Owyhee River Watershed

Total Maximum Daily Load Temperature Addendum

June 2012

State of Idaho
Department of Environmental Quality

Figure A. Watershed at a glance.

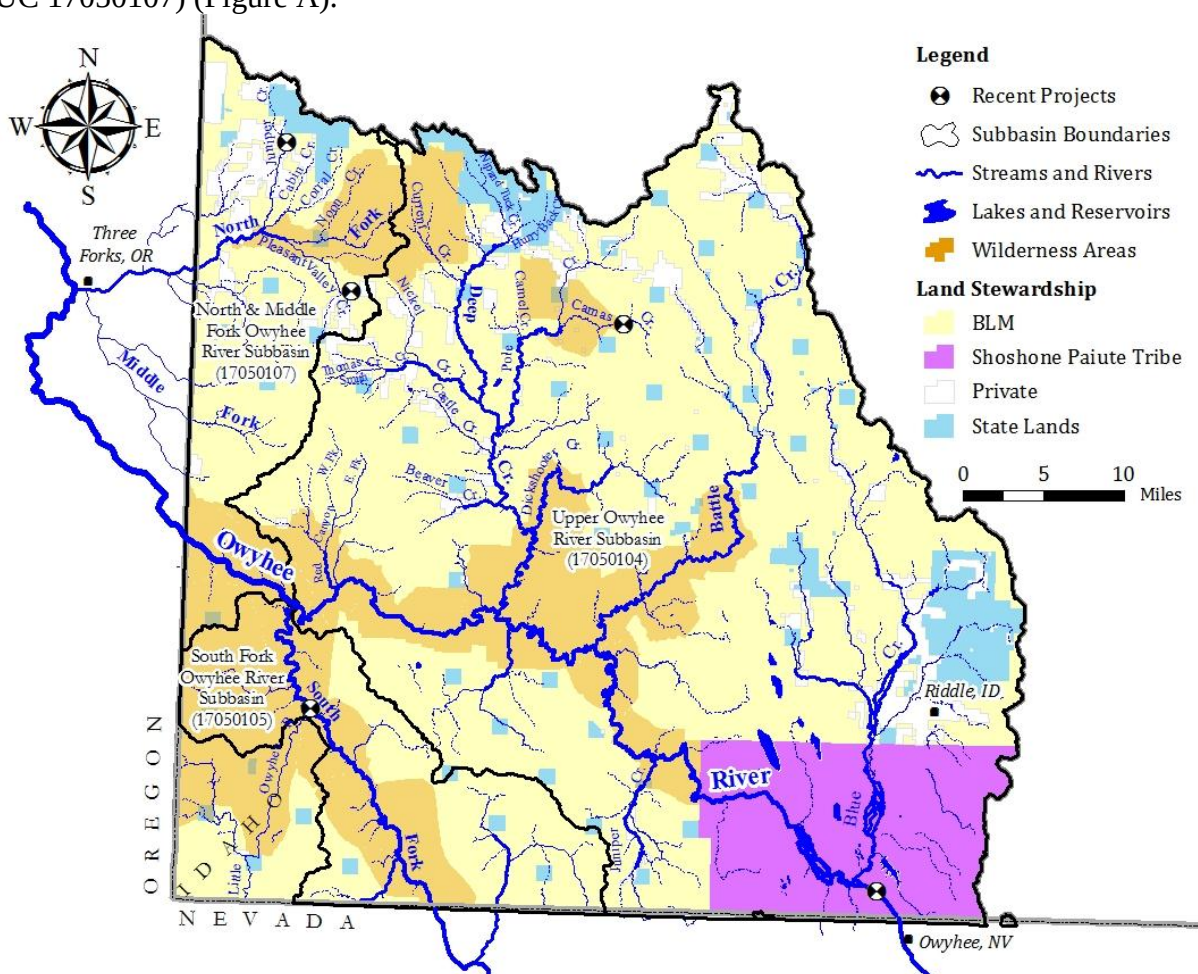
- Please change the colors in Figure A to better distinguish the Duck Valley Indian reservation from the wilderness area.

- Please show recent 319 projects on a map.

Response: done

Response: done—see Figure A

Figure C13. Lack of shade for Juniper Mountain area.

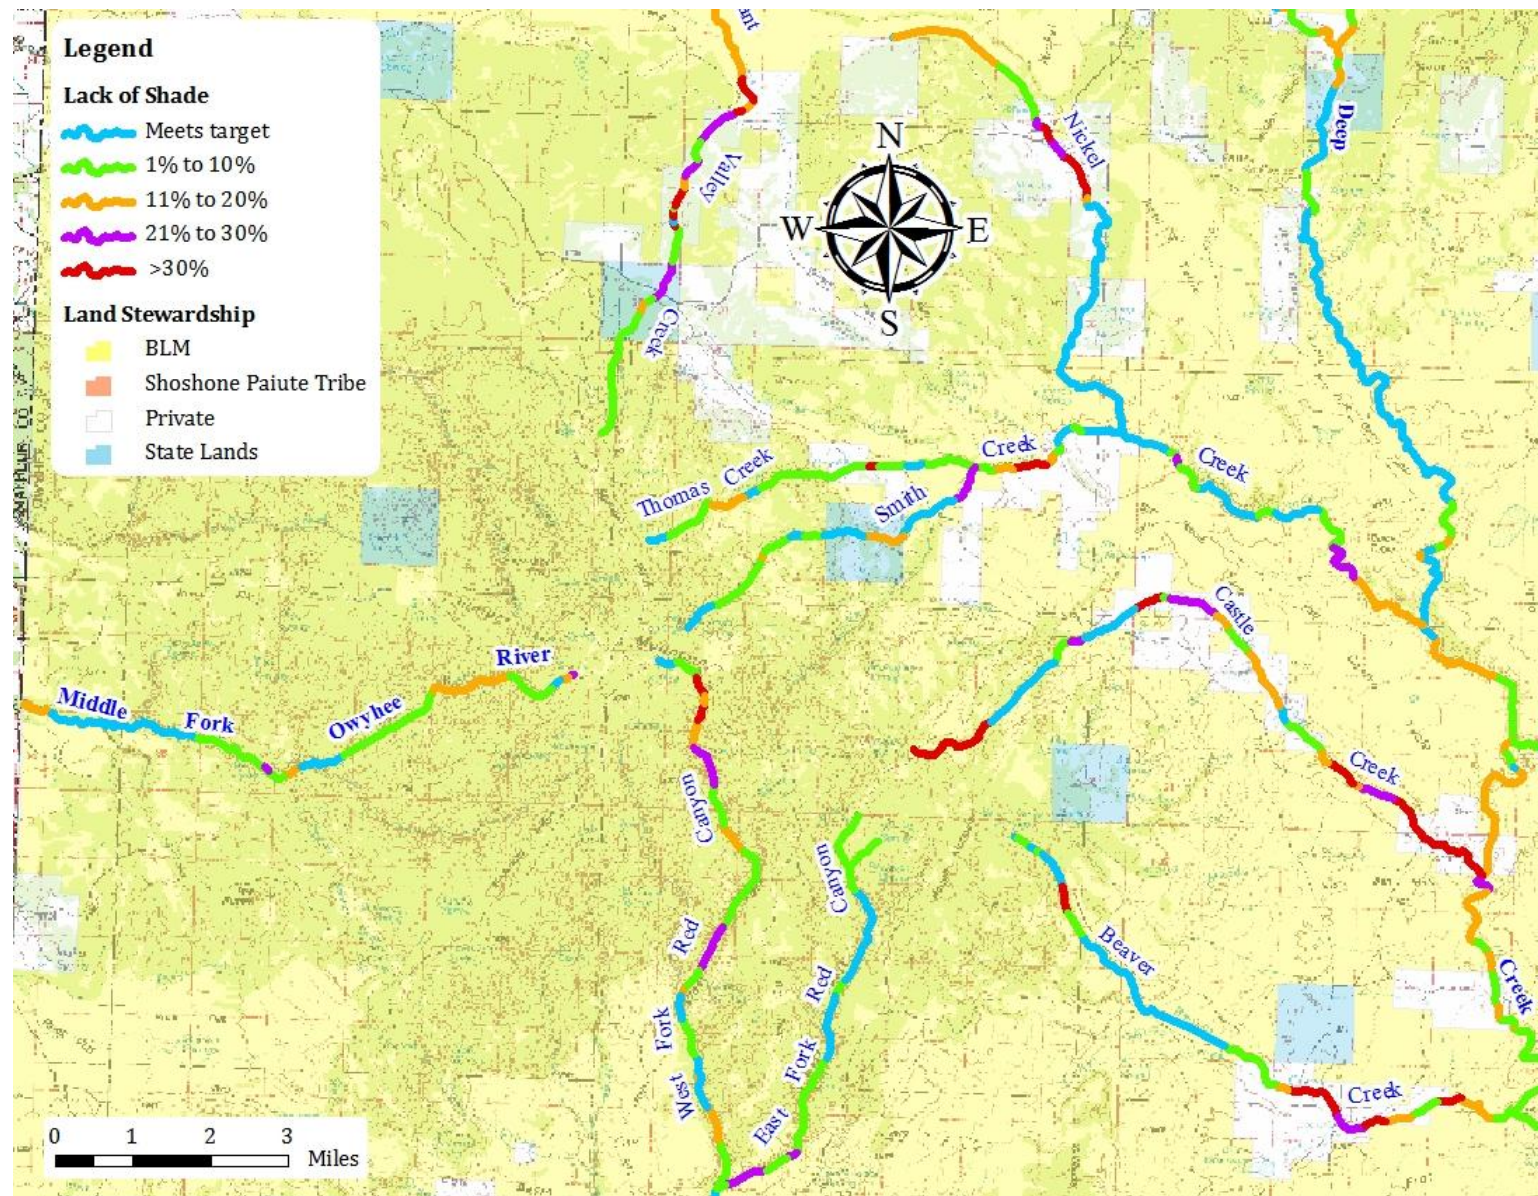
Comment 8 (5.4.1 Discussion): The TMDL contains the following statement: “Castle Creek and the lower parts of Beaver Creek have high excess loads because they lack shade for large portions of their lengths (Table 9, and Appendix C, Figure C13). Castle Creek was affected by wildfire in its headwaters, and both streams lack the protection of narrow canyons, resulting in increased access and reduced shade.”

Response: We determine the natural shade and width without regard to irrigation or reservoirs. We believe that the natural bankfull width of this segment of the Castle Creek channel increases from 4m to 6m as one moves downstream from Star Reservoir to Deep Creek. We based our estimate on hydrologic models, consistent with other similar streams in the watershed.

We agree that the natural flow of this part of Castle Creek is likely to be very small, but that does not change our belief that the climax vegetative community is coyote willow. Upstream of the Star Reservoir, Castle Creek generally meets its shade targets, except for the area affected by the wildfire.
